Request for Information (RFI)/ Design Clarification/Variation Request (DCVR)

Project Name:	Tanana Elders Lift Station		
Date:	July 20, 2011	Response Need Date:	
RFI#: RFI-		DCVR#:	DCVR-001 – Relocate Elders Lift Station
Submitted to:	Village Safe Water Project Engineer		
From (Company):	CE2 Engineers – Construction Division		
By:	Brian Aklin—CE2 Construction Project Manager

Nature of Work:	Installation of an E-One Sewage Lift Station and connecting piping
Reference Drawings:	HDR-IFC October 2010 #135830 Elders Lift Station
Reference Spec Section(s):	
Bid Item(s):

Sheet No. C2.0
SHEET 3 of 8

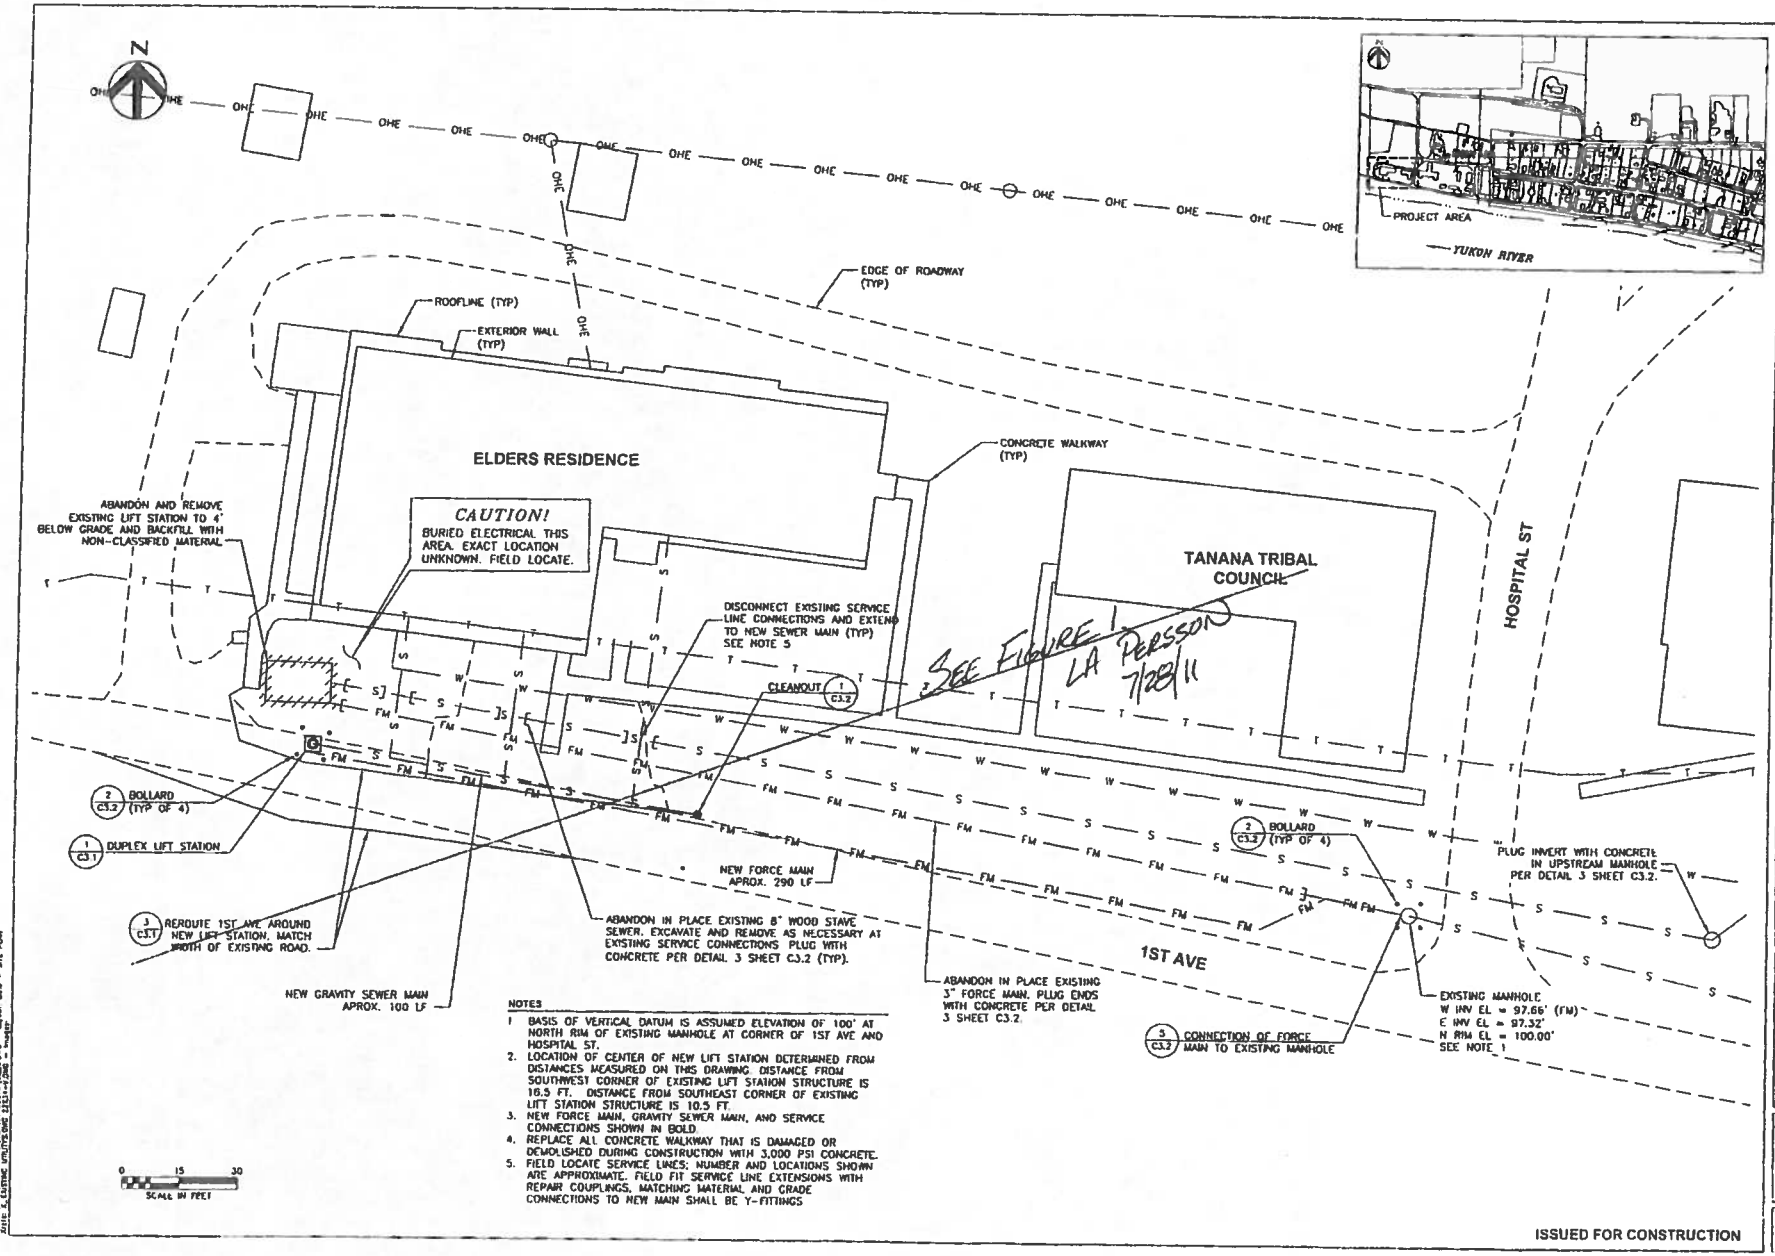
Waste service lines from Elders Residence are not as shown on Referenced Drawings. Plan Sheet C2.0 attached. Excavating for service lines located a sewer line not shown on the Plans. Research of existing plan files located a 1984 plan (attached) showing the sewer line configuration as it appears to exists currently. The Elders Residence and Tribal Council building are connected to a line flowing to the east. Flows also enter this line from further east. Local knowledge indicated this flow is from the "grey house". Cleaned manhole indicated to be plugged on plan sheet C2.0 and observed flows from east.

THE PROPOSED ELDERS LIFT STATION RELOCATION IS APPROVED AS NOTED. THE INTENT OF THE ORIGINAL DESIGN HAS BEEN MET. ADDITIONAL SITE CONTROL IS NOT REQUIRED AND SERVICE TO EXISTING UTILITY CUSTOMERS WILL BE MAINTAINED. PROJECT COST IS NOT EXPECTED TO INCREASE. 7/28/11

FIGURE 1 1/6

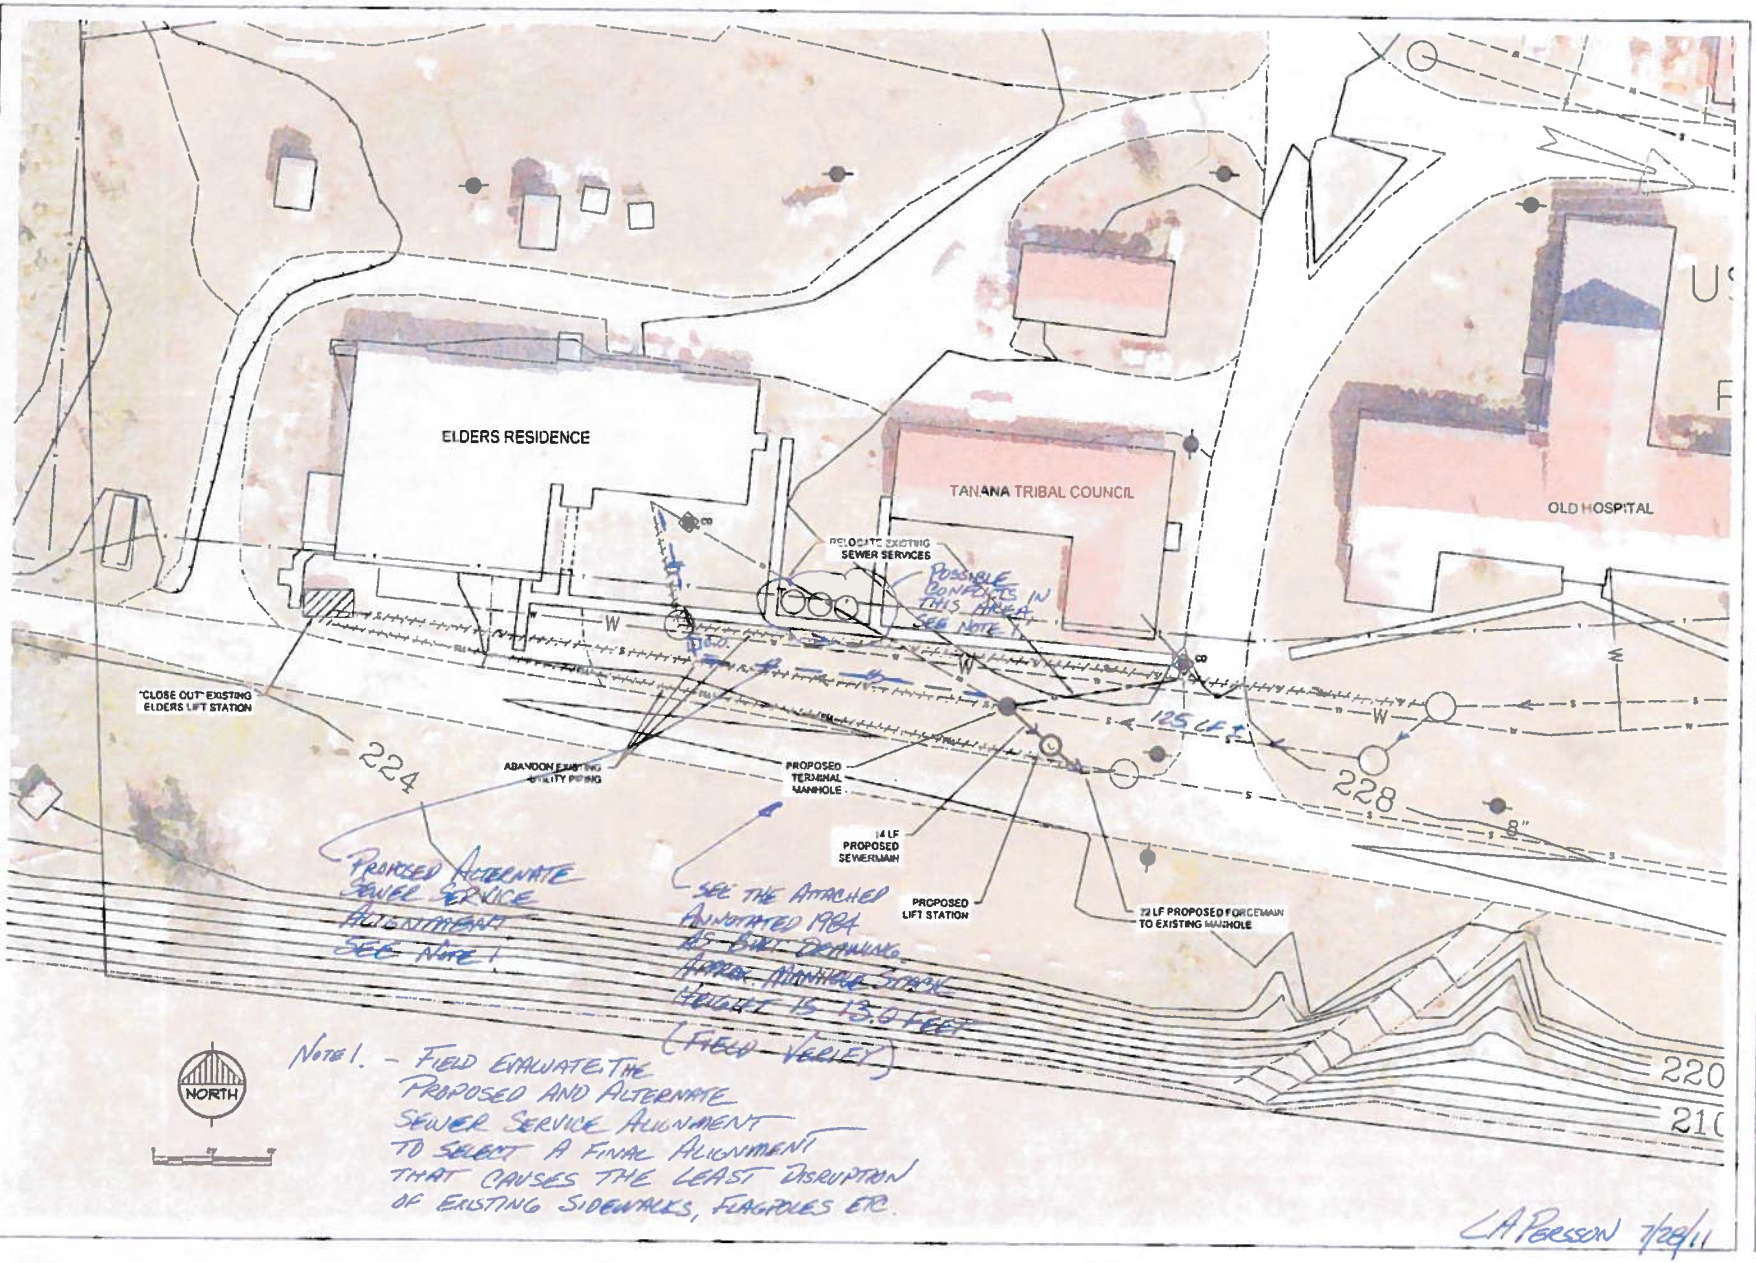
Recommend lift station location be moved as shown on attached Figure 1 and a terminal manhole be placed over the existing sewer line to collect flows from the east and to terminate the service lines for the Elders Residence and the Tribal Council Building. As shown on the Water and Sewer Key Map (Sheet G-3 attached) this construction will not occur in the soil contaminated locations. This relocation will require a shorter force main and sewer main. Electrical service can be accessed through a drop from the power line located along Hospital Street. The E-One lift station (according to the manufacturer's literature) will be adequate to handle the potential increased flows from the Tribal Council building and the connections to the east.

Note 1. - Field evaluate the proposed and alternate sewer service alignment to select a final alignment that causes the least disruption of existing sidewalks, flagpoles etc.

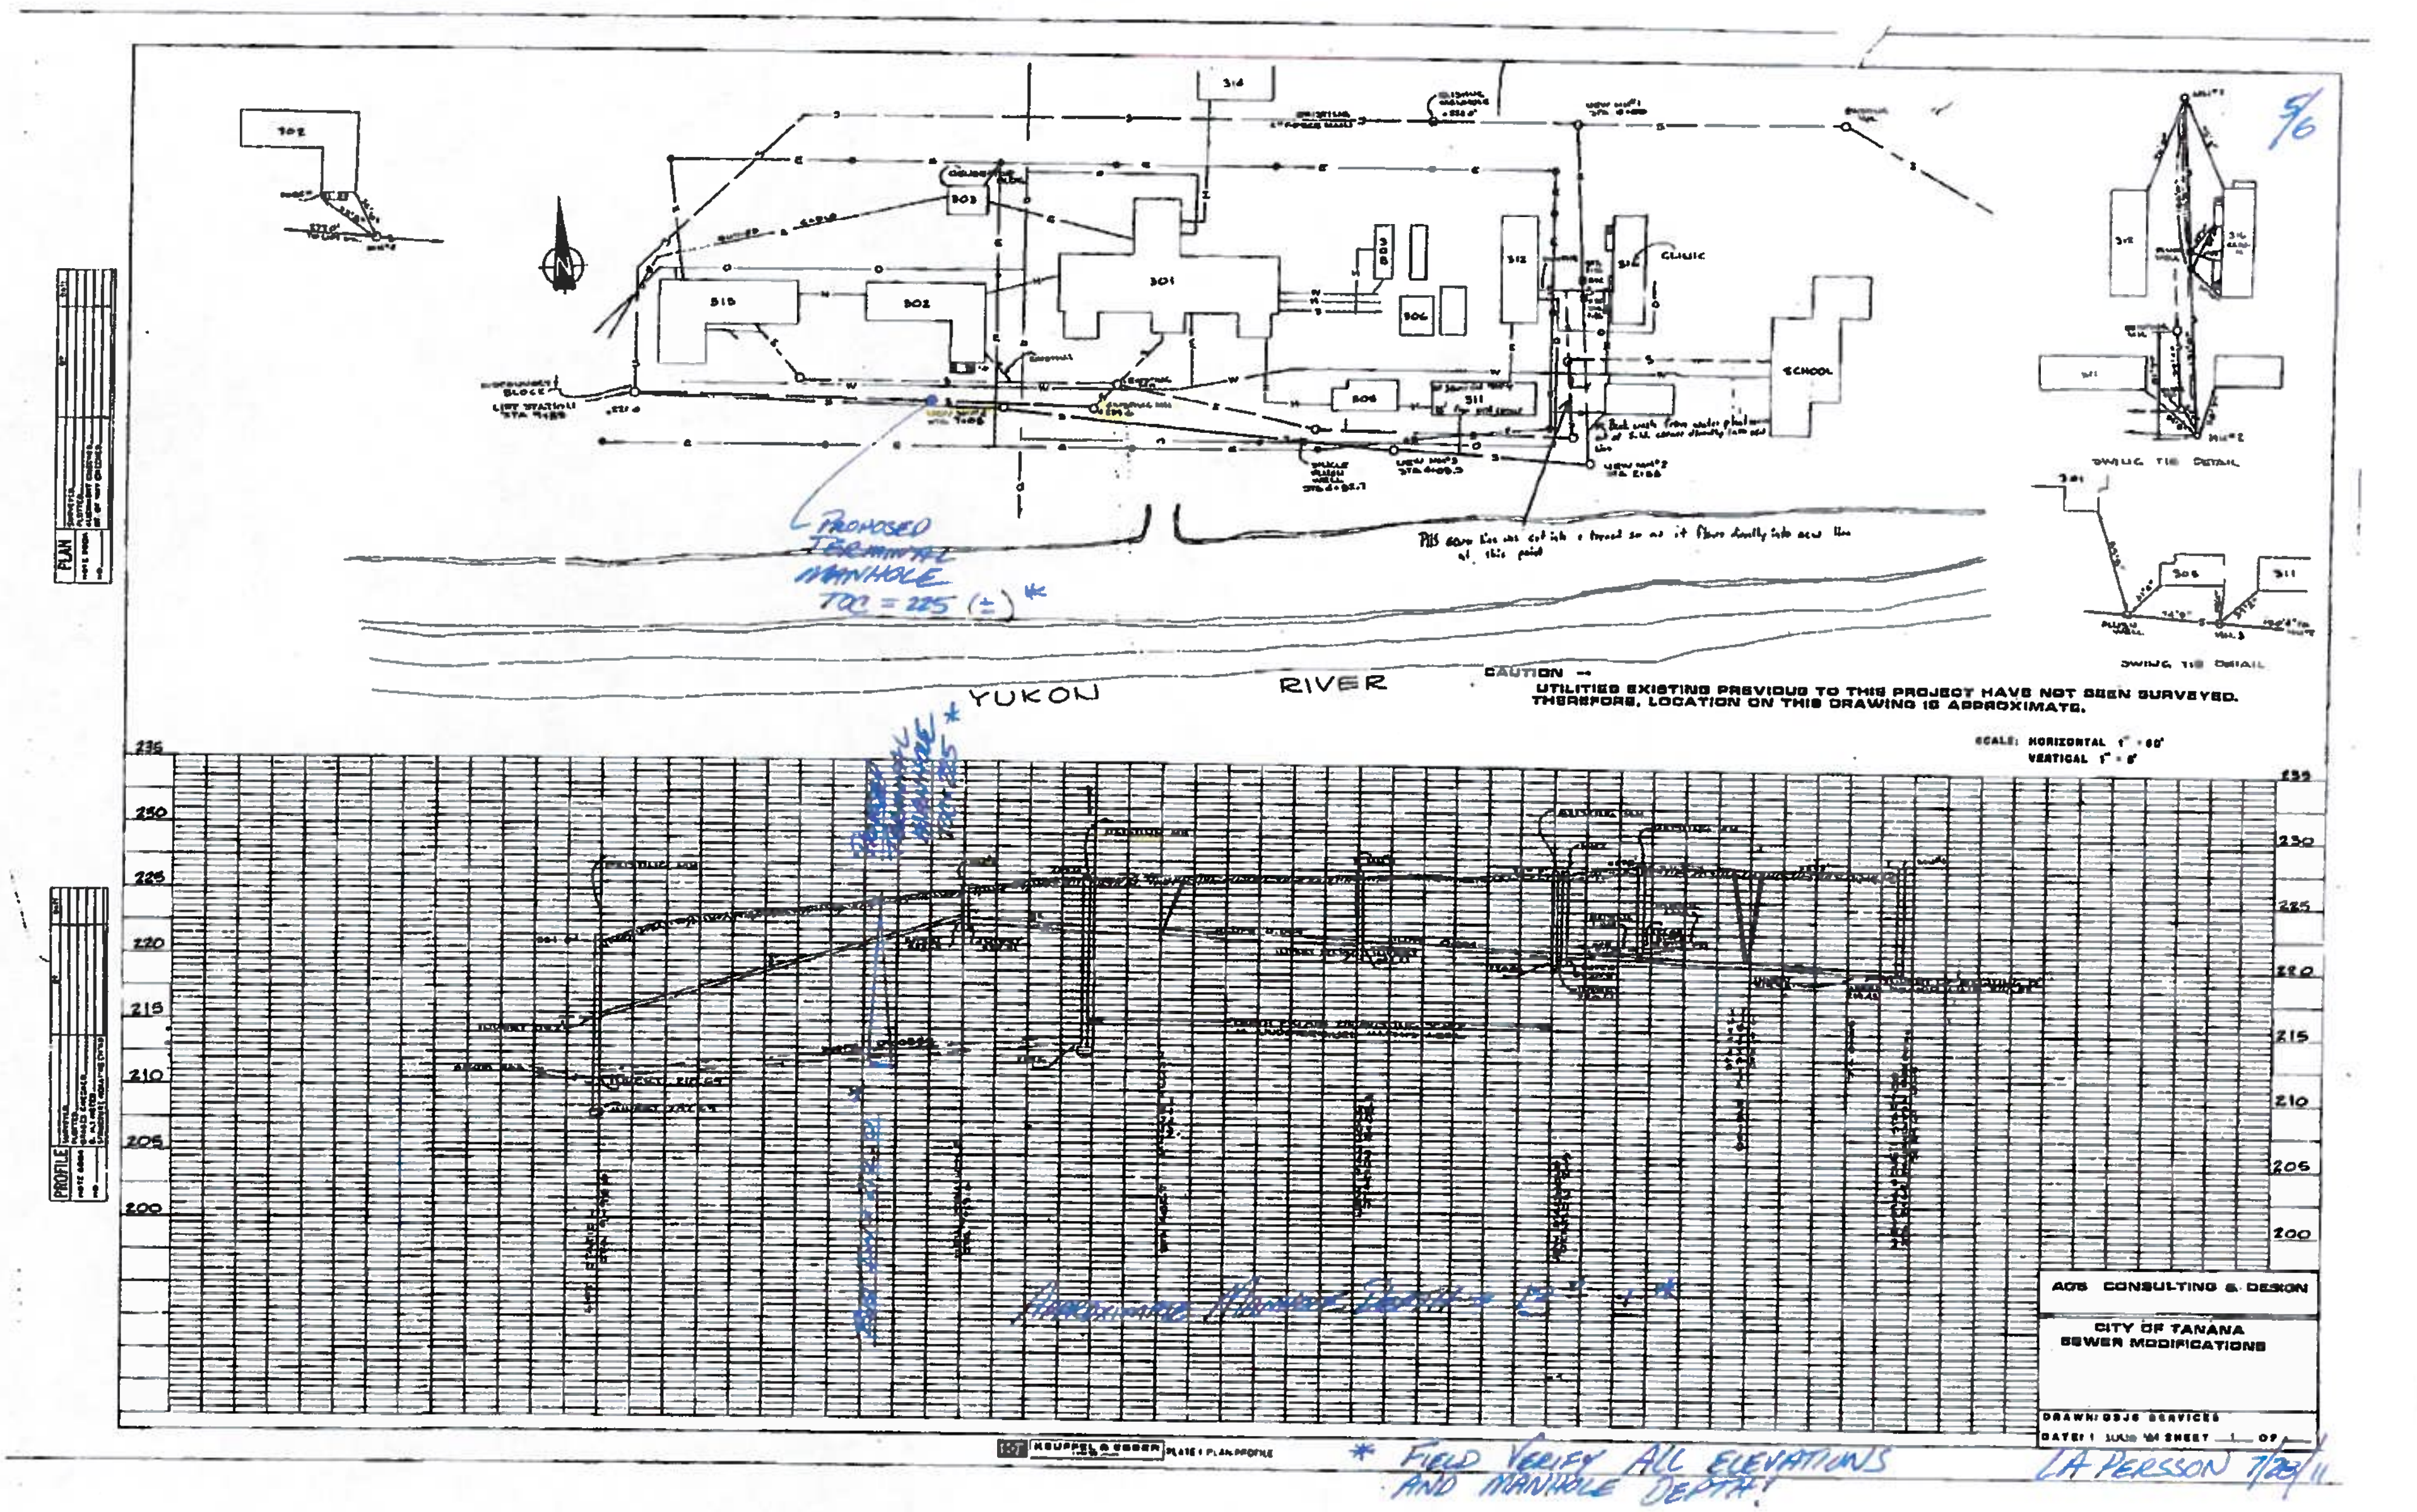
5/6
PROPOSED TERMINAL MANHOLE TOC = 225 (±) *
YUKON RIVER
CAUTION — UTILITIES EXISTING PREVIOUS TO THIS PROJECT HAVE NOT BEEN SURVEYED. THEREFORE, LOCATION ON THIS DRAWING IS APPROXIMATE.
SCALE: HORIZONTAL 1" = 60' VERTICAL 1" = 6'
SCHOOL
CLINIC
SWING TIE DETAIL
PLAN
PROFILE
AOS CONSULTING & DESIGN
CITY OF TANANA
SEWER MODIFICATIONS
KEUFFEL & ESSER
* FIELD VERIFY ALL ELEVATIONS AND MANHOLE DEPTH
LA PERSSON 7/28/11
